Intel Technical Advisory

TA-1011-01

I²C CABLE CONNECTION ISSUE WITH INTEL[®] SERVER SYSTEM P4208CP4MHGC

Figure 3. Cascaded I²C cable connection for two backplanes

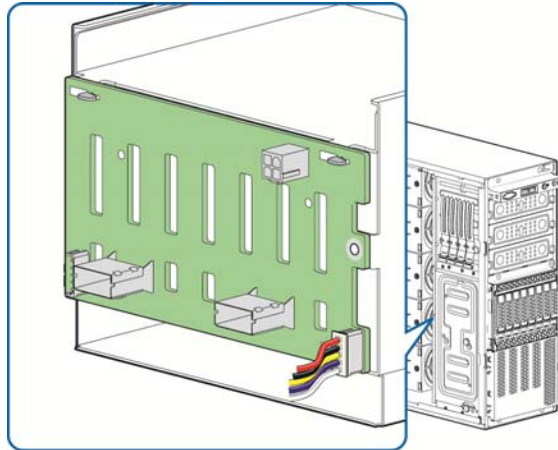
When installing a second backplane in the Intel[®] Server System P4208CP4MHGC, the two backplanes need to be cascaded with two I²C cables. The first I²C cable should connect to the "I2C_IN" connector on the first backplane, and the second I²C cable should connect from the "I2C_OUT" connector on the first backplane to the "I2C_IN" connector on the second backplane (Figure 3).

Figure 1. I²C cable is connected to the "I2C_OUT" connector

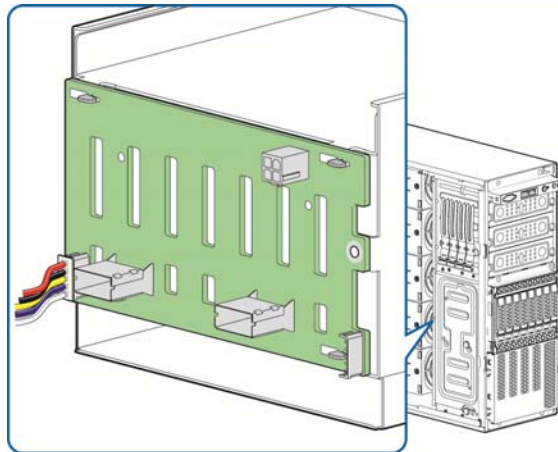
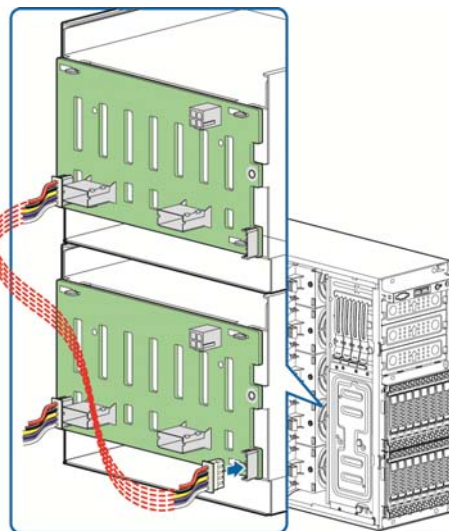
In the Intel[®] Server System P4208CP4MHGC with the above mentioned Serial Numbers, the I²C cable is connected to the connector labeled "I2C_OUT" on the backplane (Figure 1). However, to install a second backplane in the system, the I²C cable needs to be connected to the connector labeled "I2C_IN" on the original installed backplane (Figure 2).

Intel is implementing a change in manufacturing to connect the I²C cable to the "I2C_IN" connector on the original backplane in the Intel[®] Server System P4208CP4MHGC, as shown in Figure 2 above.

Customers should connect the I²C cable to the "I2C_IN" connector on the original backplane (Figure 2) in the Intel[®] Server System P4208CP4MHGC.
